December 5, 2016

RE: PennEast Pipeline Company, LLC; FERC Docket No. CP15-558-000 regarding proposed route modifications issued for public comment – request for formal extension of comment period

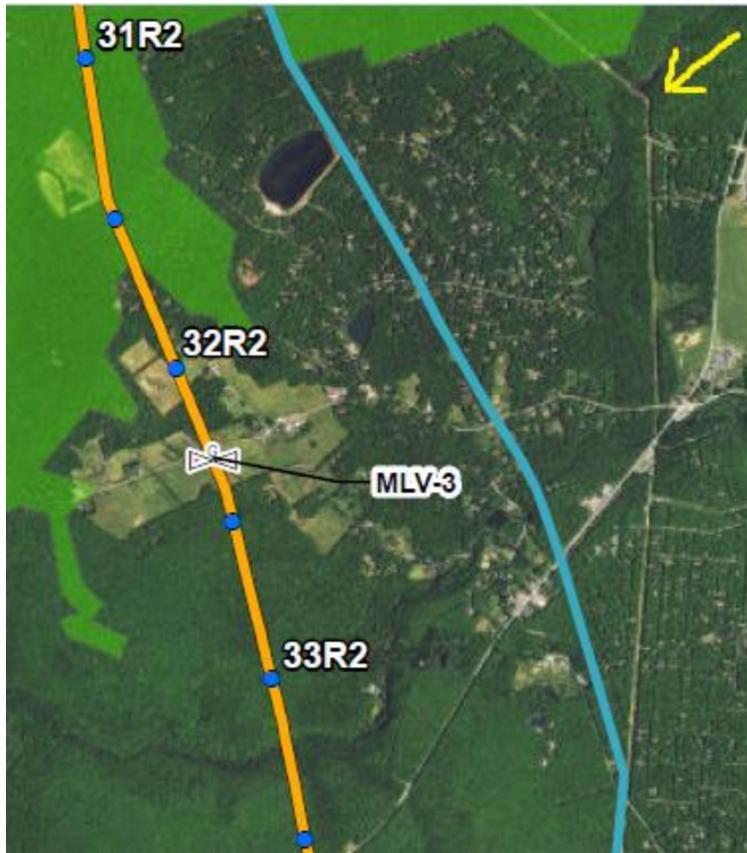
DRN Response: The IBA Avoidance alternative for Hickory Run State Park routes the pipeline going through a highly residential area before joining an existing ROW further east. Did PennEast consider collocation within the footprint of that existing ROW for the entire route to reduce fragmentation by including the pipeline in an already cleared ROW? Did PennEast consider long horizontal directional drilling (HDD) thru and under forests and sensitive habitats to reduce all the long term harms and fragmentation that comes with open cuts? For collocation it is critical the pipe be within the cleared ROW and not another swath of clear cut adjacent the ROW as that leads to more harm and more clear cuts and an expansion along an already stressed and impacted ecosystem with the existing ROW. PennEast includes acreage and length of the pipeline between the proposed route and the alternative but does not include the number of trees cut/forest inventory and whether new wetlands will be crossed or if there would be any additional impacts to natural resources. A full analysis that includes this information and data per each route should be provided for thorough public and agency review.
